Addendum No. 2

Issued: March 17, 2026

Project Name: Hatboro-Horsham School District
Simmons Elementary School Pool Decommissioning
CHA Project No. 105392

Drawing No.:
GD-100
Sheet 01 of 03

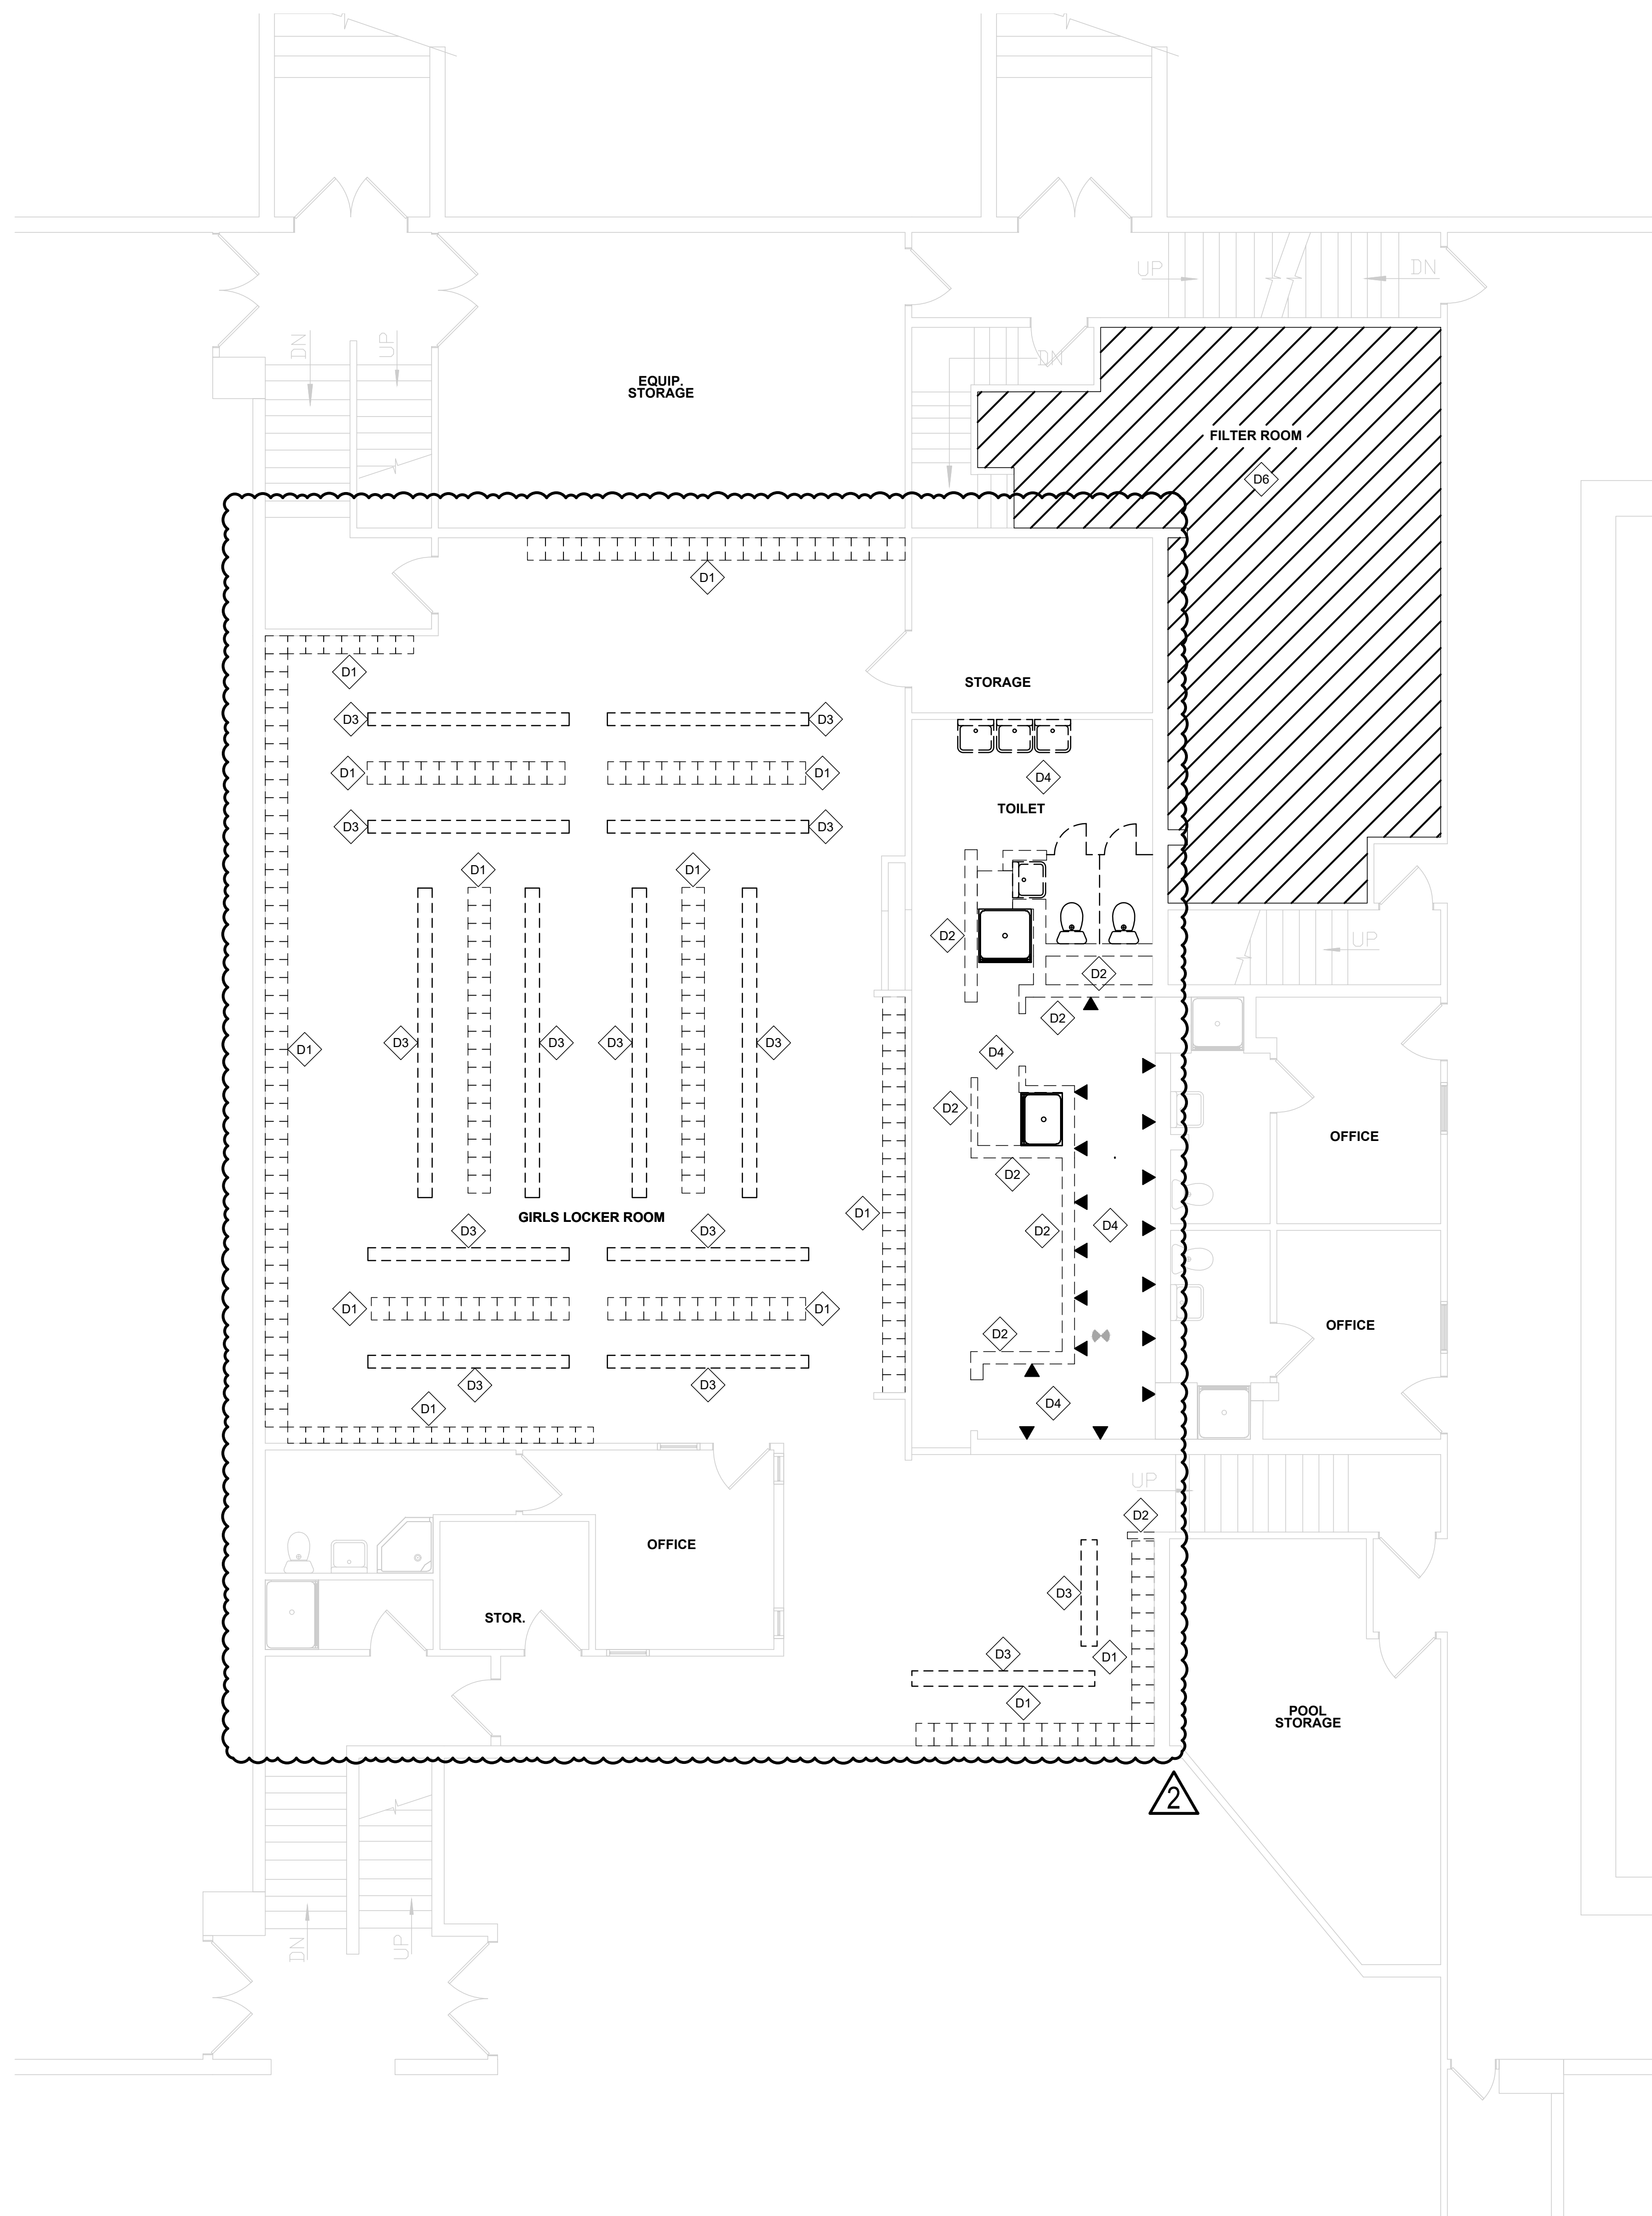
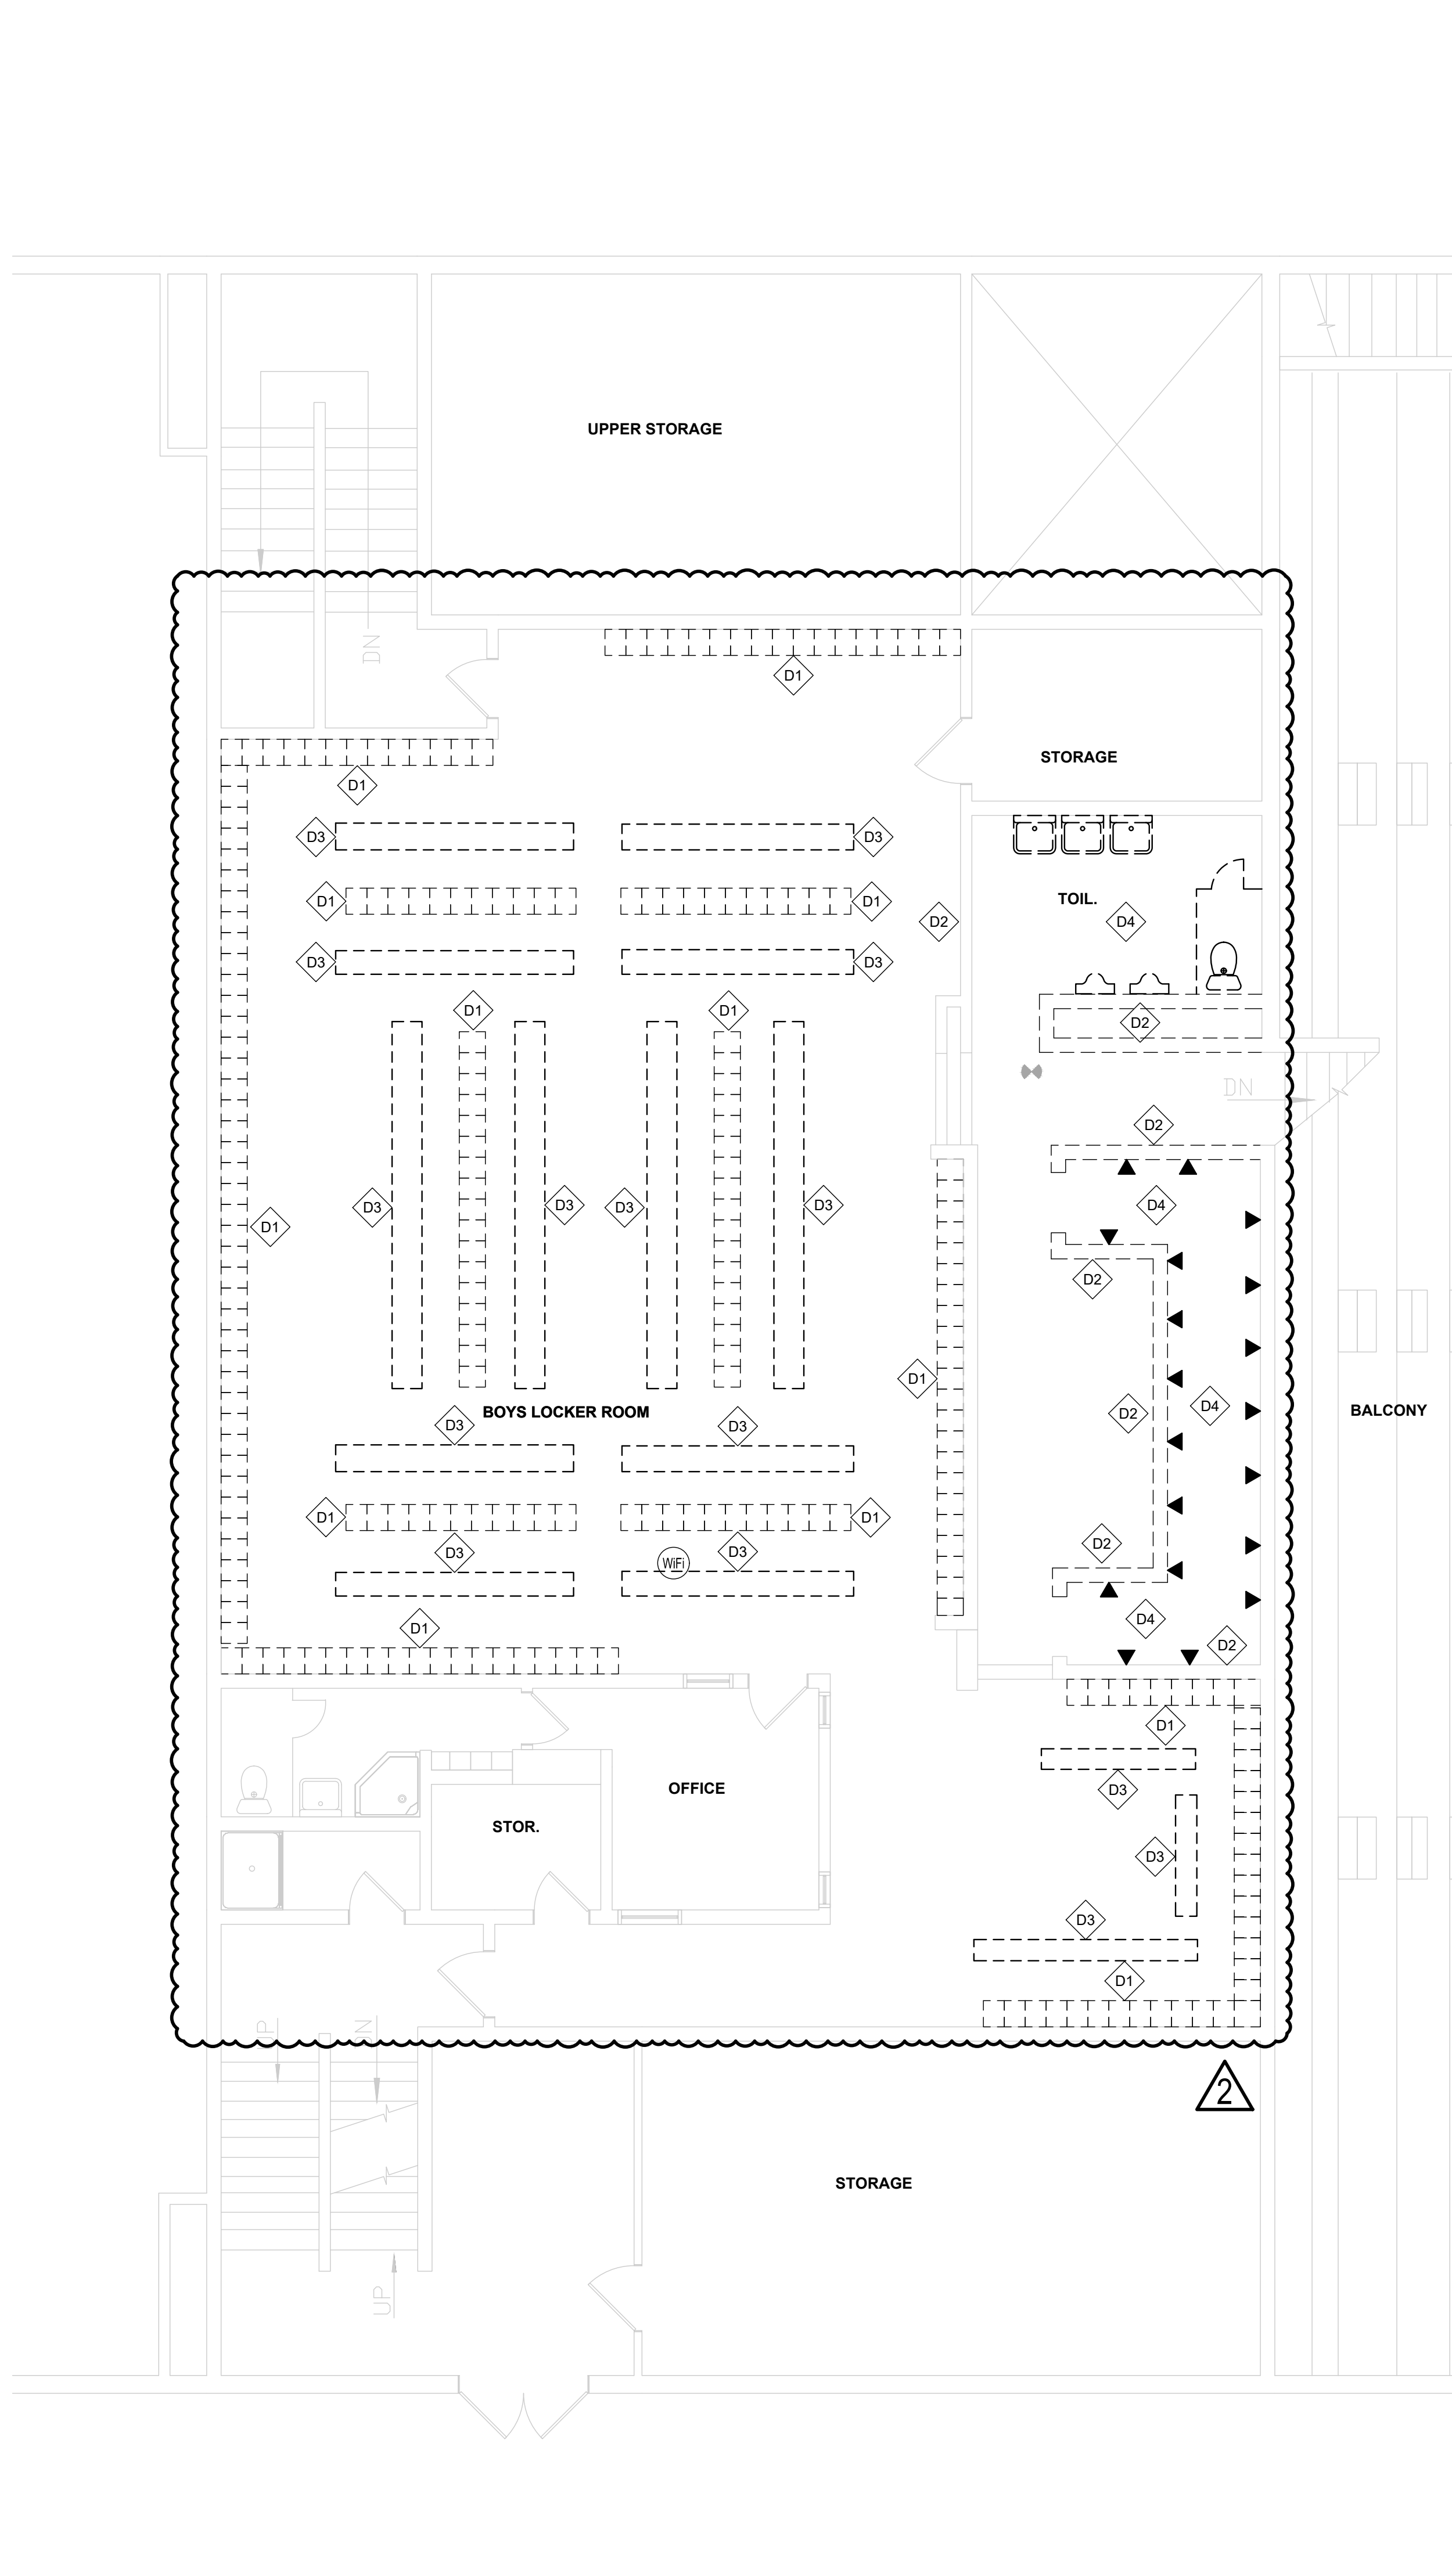
5.6 Drawing GD-100, “First and Second Floor Demo Plans”, **DELETE** in its entirety and **REPLACE** with the attached revised and reissued Drawing GD-100 included with this Addendum No. 2.

- Note: All work associates with the Coach’s Office, Storage, Restroom, and Custodial Closet have been removed from the scope of work. (This is the area in the drawing lower left of the boy’s and girl’s locker room.
